Vehicle Owner Notification

Subject: VON # 81- Heater/Defroster 3 Fuse Replacement

VEHICLE OWNER NOTIFICATION #81

SUBJECT: HEATER / DEFROSTER FUSE REPLACEMENT

FIGURE 2

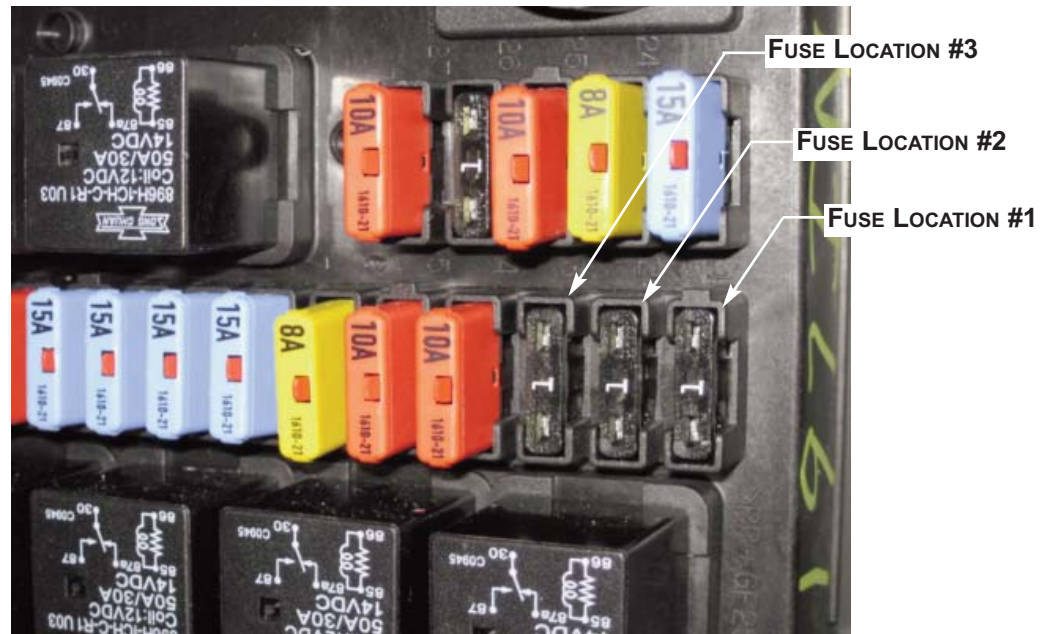
4. Locate the fuse or circuit breaker in locations #1, 2 and 3 on PC Board #1 and replace it with a 1 amp fuse - TBB 151450. **FIGURE 2**
